Addendum 12 – UN Regulation No. 13

Revision 8 - Amendment 5

Supplement 15 to the 11 series of amendments – Date of entry into force: 16 October 2018

Uniform provisions concerning the approval of vehicles of categories M, N and O with regard to braking

Figure 5A
Mechanical-transmission braking system
 (See paragraph 2.3. of this annex)

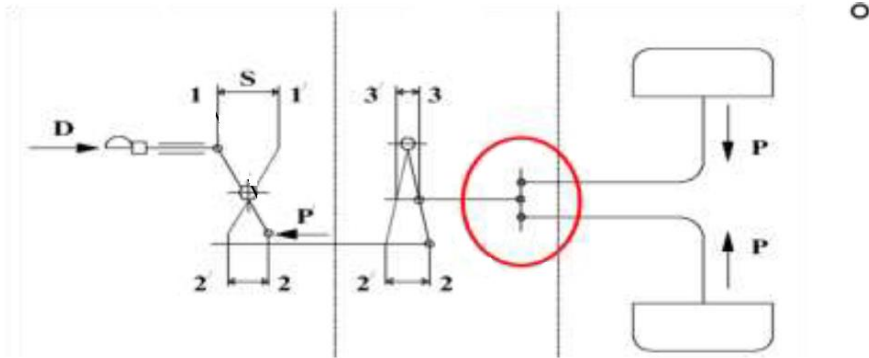
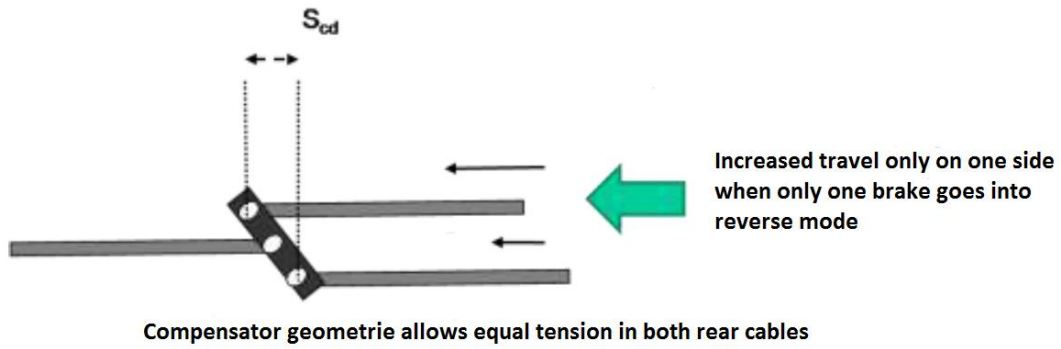
Annex 12, Appendix 1, Figure 5A, amend to read:

"2.3.10. s_{cd} Maximum differential travel that the compensator is capable to accommodate, due to its geometric and constructive properties, when only one brake operates in the forward direction and the other in reverse direction, while allowing equal tension in both cables/rods.

(See Figure 5A of appendix 1)"

Differential travel at compensator (s_{cd}) shall be derived from:

$$S_{cd} \geq 1.2 \cdot S_r$$
